**PRELIMINARY HUMAN ENGINEERING
ASSESSMENT OF THE SAINT LUCIE UNIT 2
NUCLEAR POWER PLANT CONTROL ROOM**

Florida Power & Light Company

Essex Corporation
333 N. Fairfax Street
Alexandria, Virginia 22314

June 12, 1981

Figure 5 - A typical RM-11 CRT Console (base not shown). Conductor tapes at lower right of CRT are for testing and are not part of the permanent console.

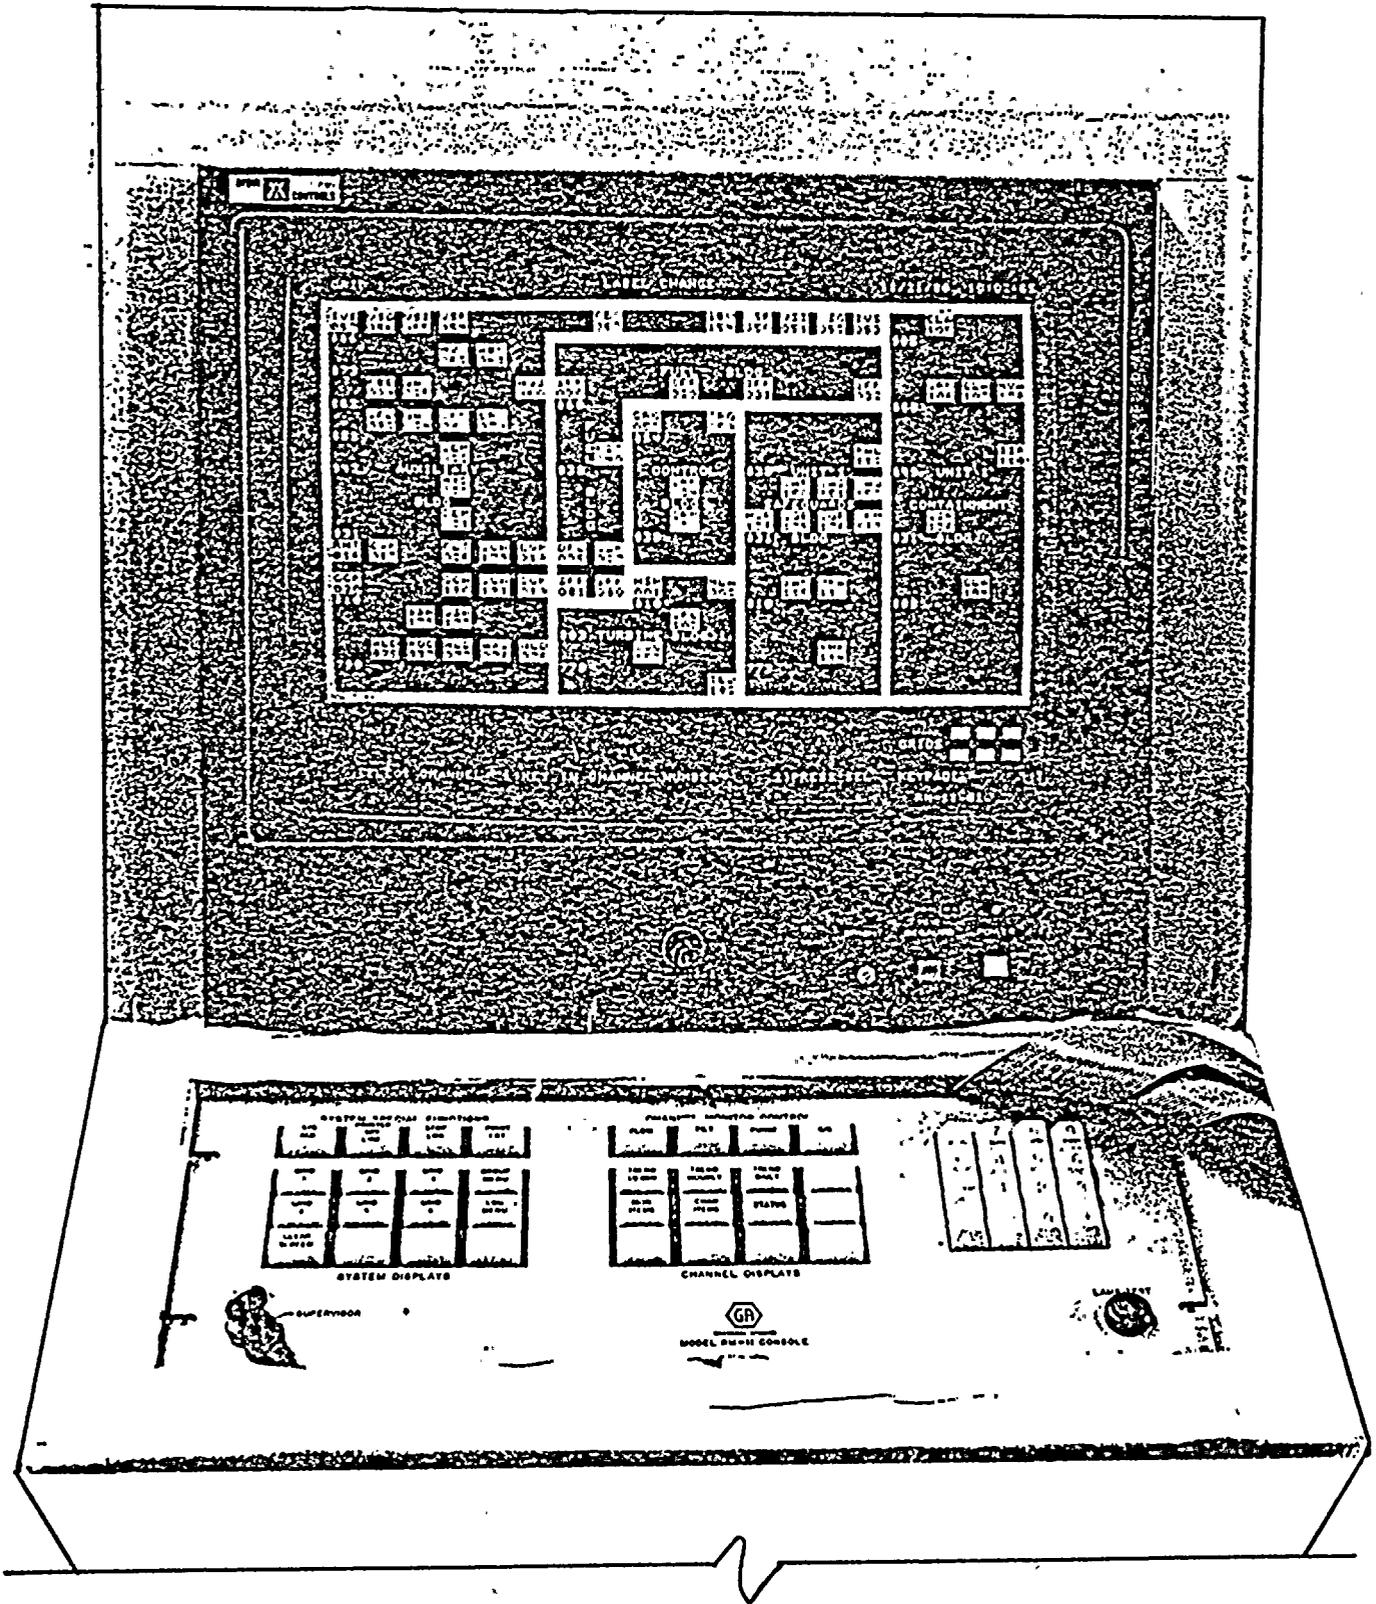
3. The RM-11 system uses a grid display (schematic layout) to represent monitor locations within the plant. A grid display logo located in the lower right corner of the screen will flash when an alarm condition is found, directing the operator to the correct grid. This grid logo lacks specific grid numbers but resembles the location of the Grid Selection buttons. Labeling of function and selection buttons is not the best, but could be sufficient with proper training.
